From: [REDACTED]
Sent: 13 December 2018 12:08
To: Planning.Responses
Subject: planning application consultation -WA/84/18/HH

Your Ref
WA/84/18/HH
Our Ref
PLAN-025532
Date
13/12/2018

Proposal: Extensions and alterations to bungalow including first floor extension. New garage with home office.
Site: Willows, West Walberton Lane, Walberton, BN18 0QS.
WA/84/18/HH

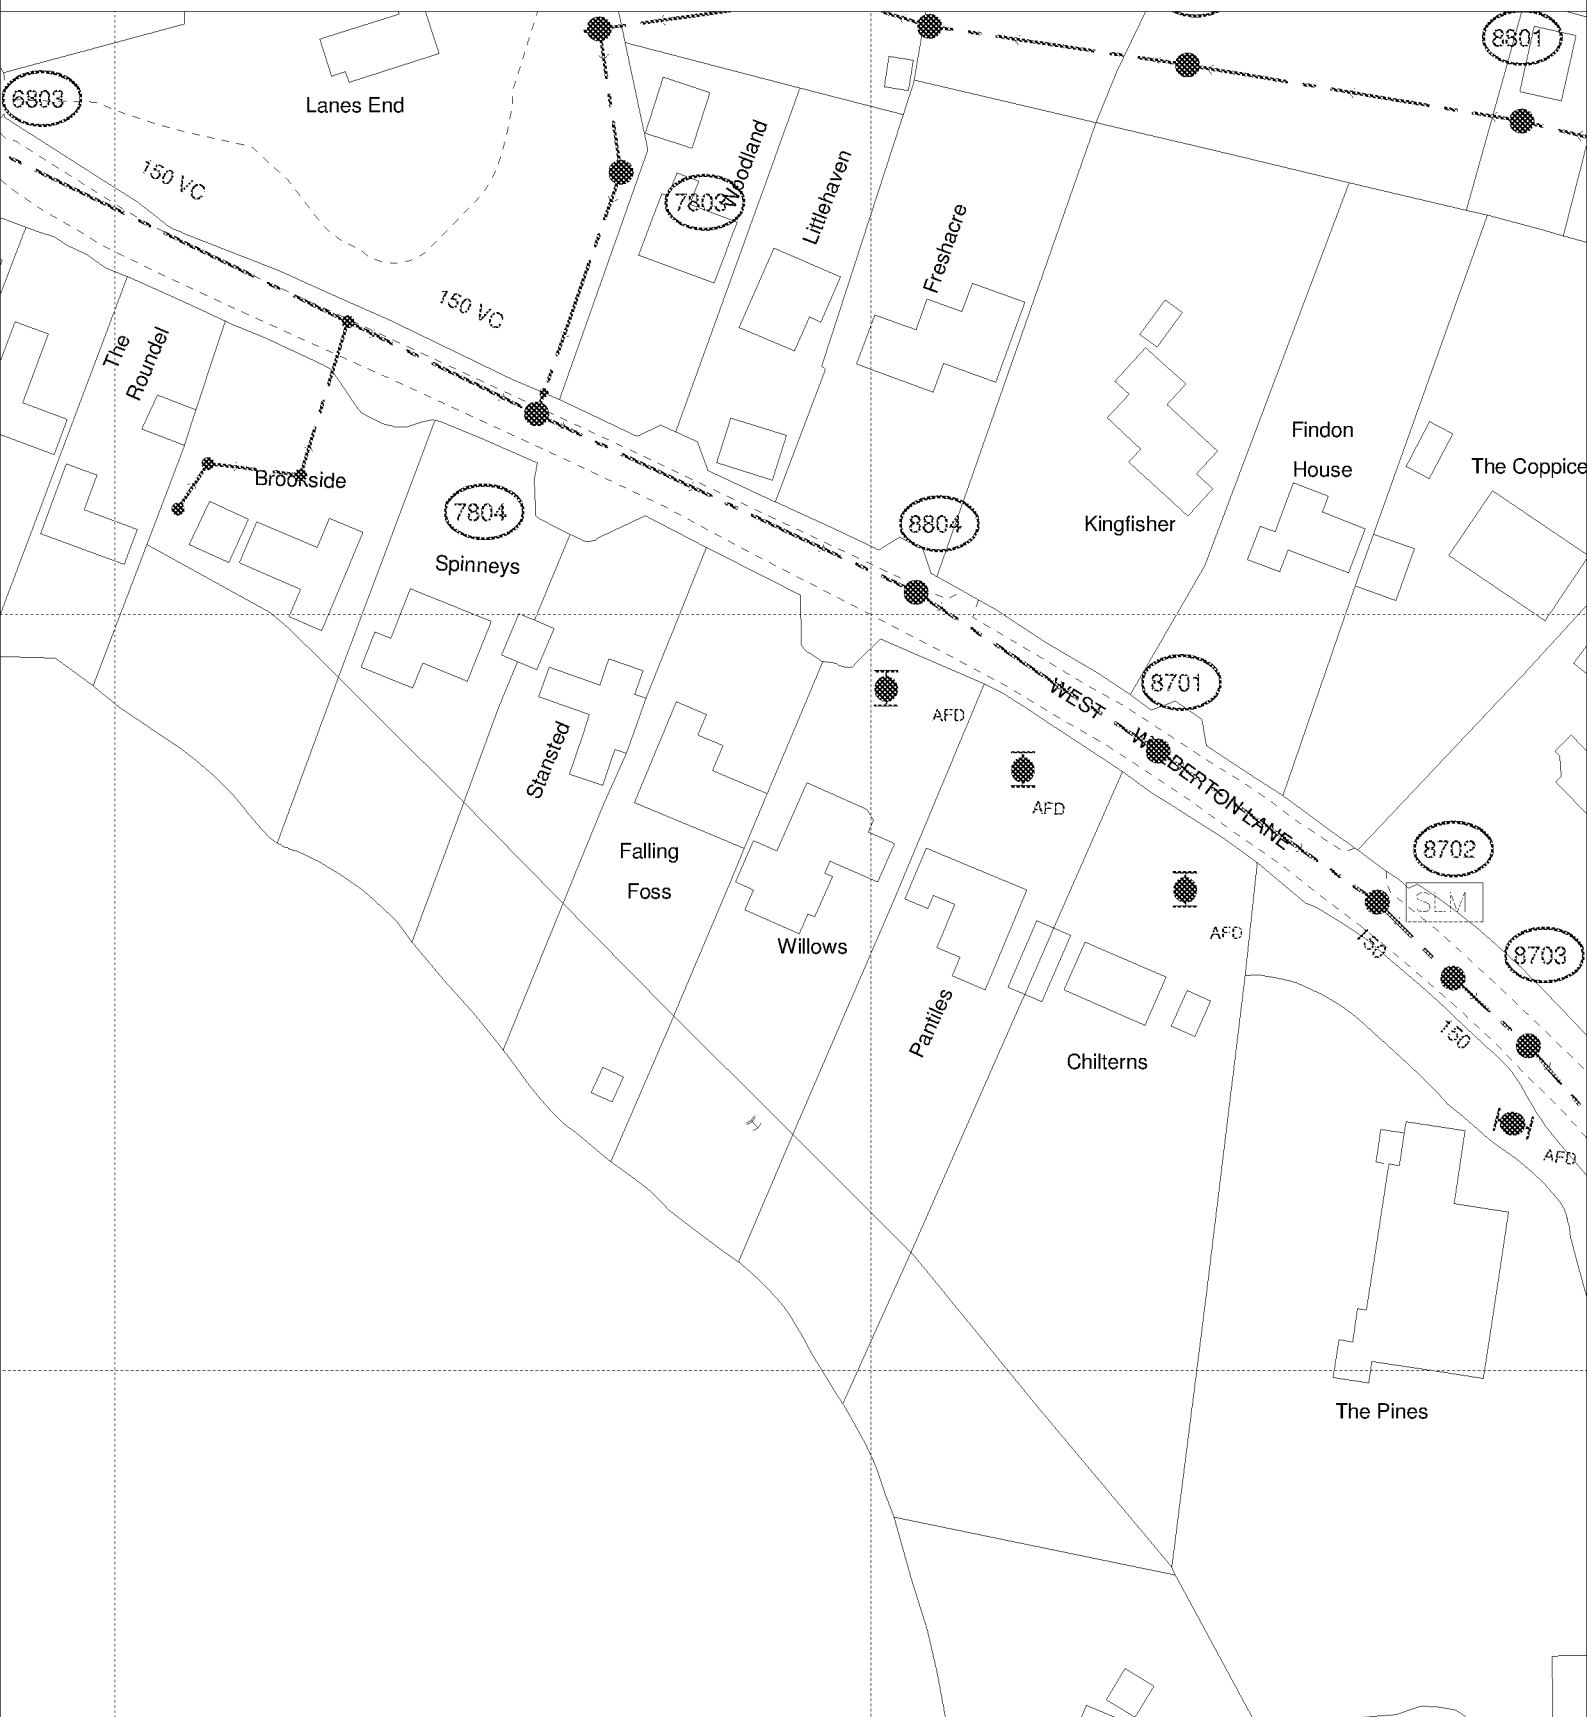
Our initial investigations indicate that there are no public surface water sewers in the area to serve this development. Alternative means of draining surface water from this development are required. This should not involve disposal to a public foul sewer.

Please note, Southern Water's records shows an AFD located within the site. Access to the AFD should be maintained at all times. The applicant is advised to discuss the

matter further with Southern Water Services with regards to future access for maintenance of the AFD.

Due to surface water inundation issues in the Lidsey Catchment "The applicant is advised to adopt, where appropriate, the measures in the table "Practical measures to reduce the potential impacts of development".
